STAFF REPORT
KETCHUM PLANNING AND ZONING COMMISSION
REGULAR MEETING OF MAY 10, 2022

PROJECT: Gem Street Subdivision Replat

FILE NUMBER: P21-101

APPLICATION TYPE: Subdivision – Preliminary Plat

SHEET 1 OF 2
 Job No. 8170

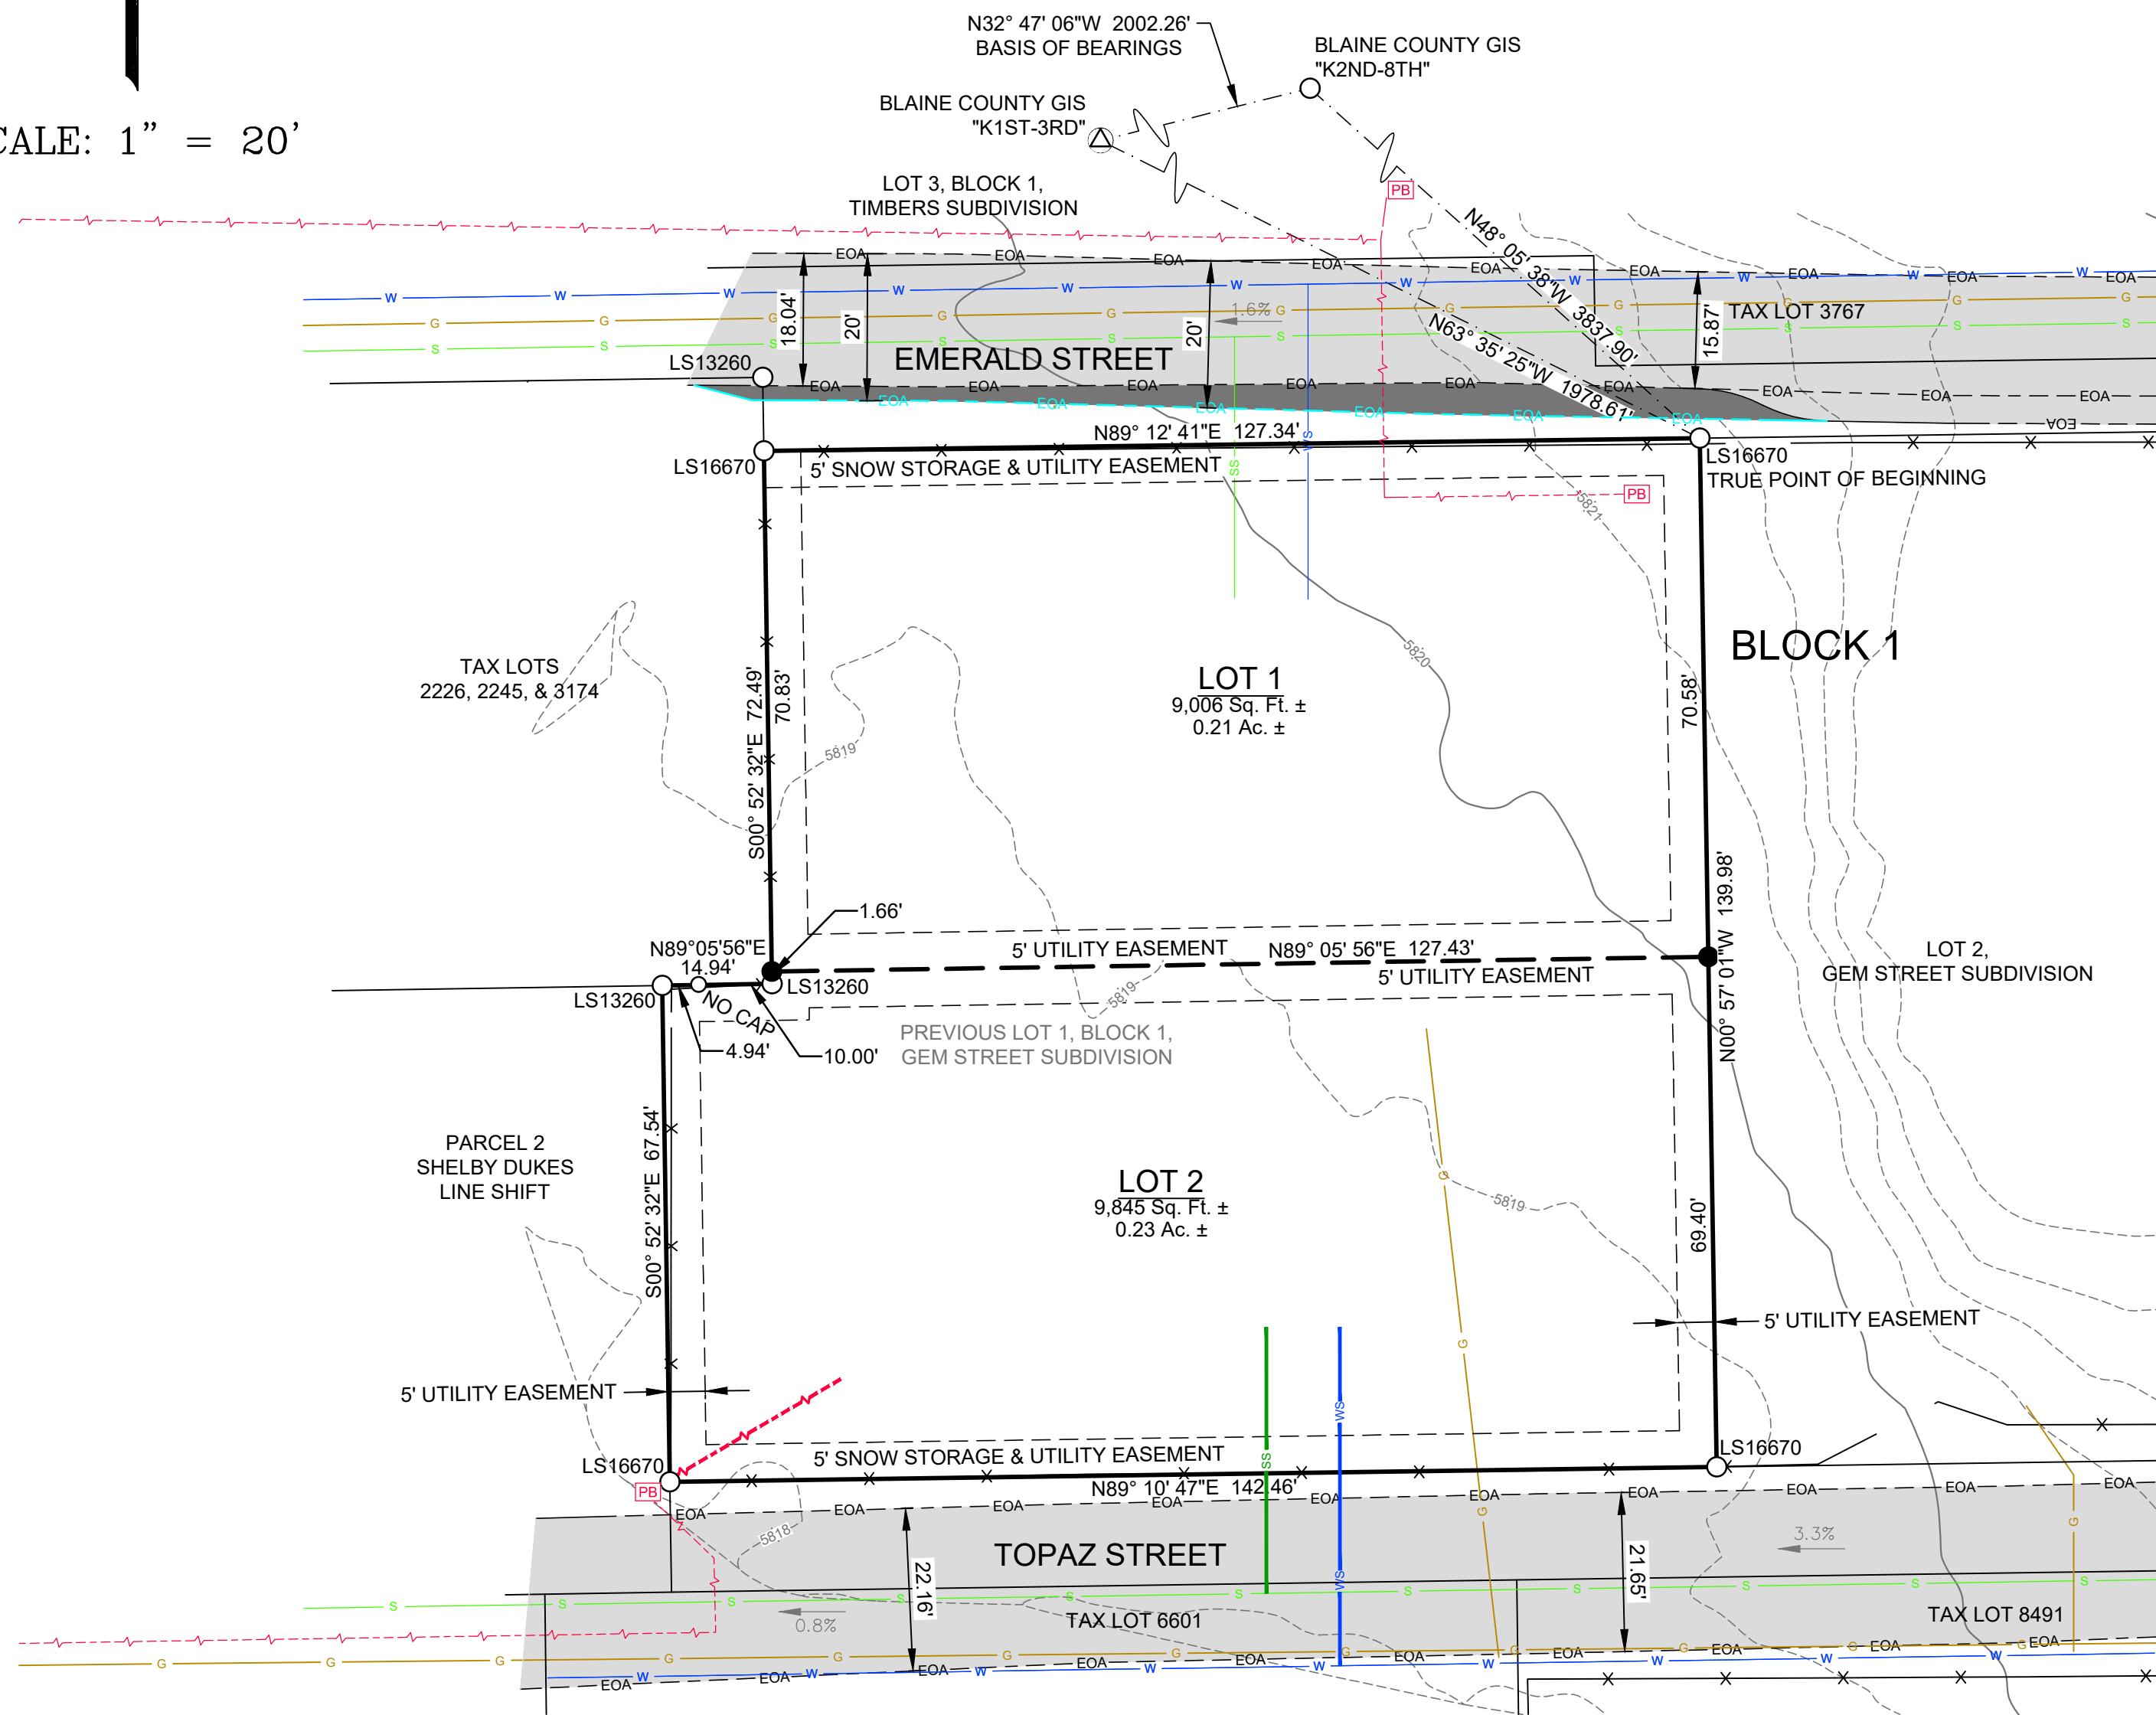
<i>Findings</i>	As shown on Sheets 1 and 2, the owner and subdivider is Christopher Brown. The plat was prepared by Mark Phillips of Galena Engineering.	
<input checked="" type="checkbox"/>	<input type="checkbox"/>	<input type="checkbox"/>	16.04.030.I .4	Legal description of the area platted.	
			<i>Findings</i>	The legal description of the area platted is shown in the Certificate of Ownership on Sheet 2 of the preliminary plat.	
<input checked="" type="checkbox"/>	<input type="checkbox"/>	<input type="checkbox"/>	16.04.030.I .5	The names and the intersecting boundary lines of adjoining subdivisions and parcels of property.	
			<i>Findings</i>	Sheet 1 of the preliminary plat indicates the boundary lines of the adjoining tax lots to the west and adjoining subdivisions, Shelby Dukes, Timbers and Gem Street Subdivision.

<i>Findings</i>	Sheet 1 provides the boundary description of the area and includes square footage and acreage of both lots.
<input checked="" type="checkbox"/>	<input type="checkbox"/>	<input type="checkbox"/>	16.04.030.I .9	Existing zoning of the tract.
			<i>Findings</i>	Plat note #3 on Sheet 1 of the preliminary plat lists the existing zoning of the subject property.
<input checked="" type="checkbox"/>	<input type="checkbox"/>	<input type="checkbox"/>	16.04.030.I .10	The proposed location of street rights of way, lots, and lot lines, easements, including all approximate dimensions, and including all proposed lot and block numbering and proposed street names.
			<i>Findings</i>	No new streets or blocks are proposed for the project; however, Sheet 1 of the preliminary plat includes names and dimensions of all existing right-of-way for Emerald Street to the north and Topaz Street to the south. Sheet 1 of the preliminary plat shows the locations and lot lines for the proposed lots.

<input type="checkbox"/>	<input type="checkbox"/>	<input checked="" type="checkbox"/>	16.04.030.I .11	The location, approximate size and proposed use of all land intended to be dedicated for public use or for common use of all future property owners within the proposed subdivision.
			<i>Findings</i>	This standard is not applicable as there is no requirement or proposal for land dedicated for public or common use.
<input checked="" type="checkbox"/>	<input type="checkbox"/>	<input type="checkbox"/>	16.04.030.I .12	The location, size and type of sanitary and storm sewers, water mains, culverts and other surface or subsurface structures existing within or immediately adjacent to the proposed sanitary or storm sewers, water mains, and storage facilities, street improvements, street lighting, curbs, and gutters and all proposed utilities.
			<i>Findings</i>	Sheet 1 shows the water and sewer lines to serve both lots.

<i>Findings</i>	As shown on Sheet 1 of the preliminary plat, all proposed improvements to the public right-of-way are shown. As outlined in condition of approval #3, all right-of-way improvements are required prior to approval of the Final Plat. The subject

<i>Findings</i>	<p>As shown on Sheet 1 of the preliminary plat, Lot 1 and Lot 2 include a 5-foot snow storage and utility easement. Both lots include 5-foot utility easements along all property boundaries.</p> <p>Standards 2-6 do not apply to the project as the property is not adjacent to any of the listed waterways, not adjacent to Warm Springs, does not contain any irrigation infrastructure, and does not include pedestrian or equestrian pathways.</p>
<input type="checkbox"/>	<input type="checkbox"/>	<input checked="" type="checkbox"/>	<p>16.04.040.K Sanitary Sewage Disposal Improvements: Central sanitary sewer systems shall be installed in all subdivisions and connected to the Ketchum sewage treatment system as a required improvement by the subdivider. Construction plans and specifications for central sanitary sewer extension shall be prepared by the subdivider and approved by the city engineer, council and Idaho health department prior to final plat approval. In the event that the sanitary sewage system of a subdivision cannot connect to the existing public sewage system, alternative provisions for sewage disposal in accordance with the requirements of the Idaho department of health and the council may be constructed on a temporary basis until such time as connection to the public sewage system is possible. In considering such alternative provisions, the council may require an increase in the minimum lot size and may impose any other reasonable</p>

<i>Findings</i>	As shown on Sheet 1 of the preliminary plat, new utilities will be installed underground. Utility locations will be reviewed and verified at the time of building permit application.
<input type="checkbox"/>	<input type="checkbox"/>	<input checked="" type="checkbox"/>	16.04.040.Q	Off Site Improvements: Where the offsite impact of a proposed subdivision is found by the commission or council to create substantial additional traffic, improvements to alleviate that impact may be required of the subdivider prior to final plat approval, including, but not limited to, bridges, intersections, roads, traffic control devices, water mains and facilities, and sewer mains and facilities.
			<i>Findings</i>	The proposed subdivision does not create substantial additional traffic, therefore, no improvements are required.

1. Prior to construction of required improvements, construction plans for proposed improvements to Emerald Street shall be reviewed and approved by the City Engineer.
2. All fences located within snow storage easements must either be relocated or removed entirely and verified by a member of the City of Ketchum Planning staff, prior to approval of the Final Plat.
3. All right-of-way improvements shall be completed and accepted by the City of Ketchum City Engineer prior to approval of the Final Plat.
4. Failure to record a Final Plat within two (2) years of Council's approval of a Preliminary Plat shall cause the Preliminary Plat to be null and void.
